MTTE-DPE (70-47a)

26 Feb 97

SUBJECT: Final Transportability (TR) Engineering Analysis and Approval for the M1101 and M1102 High Mobility Trailers (HMTs) (TR 90-4v-16)

Figure 1. M1101/M1102 with soft-top kit.

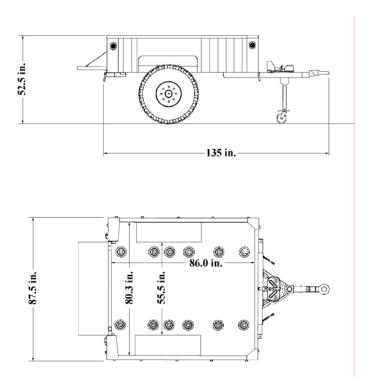
- 3. Our analysis shows that the M1101 and M1102 (see fig 1), which are identical trailers (except for the payload capacity) that have the same tires, wheels, and track width as the High Mobility Multipurpose Wheeled Vehicle (HMMWV), meet their transportability requirements as stated in the purchase description (ref 1b), except for the cargo tiedown provisions (see paragraph 3h). We used data provided in reference 1c (summarized in fig 2 and table 1) as the basis for our analysis and approval. A summary of our analysis of the M1101 and M1102 follows:

- 2. In accordance with reference 1a, we are granting TR approval for type classification-standard and concur with full materiel release for the M1101 and M1102 for highway, rail, marine, and air transport modes subject to the restrictions in paragraph 3.
